WETLAND DELINEATION, G, J, K, V
 ODE FERRIS PLANT
 MONROE COUNTY, MICHIGAN

CAD FILE: Wetland Delineation 00
 DESIGNED BY: --
 DRAWN BY: GE, DA
 SURVEYED BY: GL, WW, FW
 BOOK NO. # 18 PAGE 13-19
 DATE: 7/7/08
 PROJECT NO.: US-MI-188-1
 GLARO-MI3-46-9

WETLAND DELINEATION I
 MONROE COUNTY, MICHIGAN

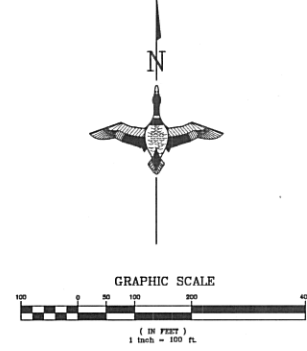
USACE NOTE:
AREA L: ENLARGE-CONNECT WL 69 to WL 74
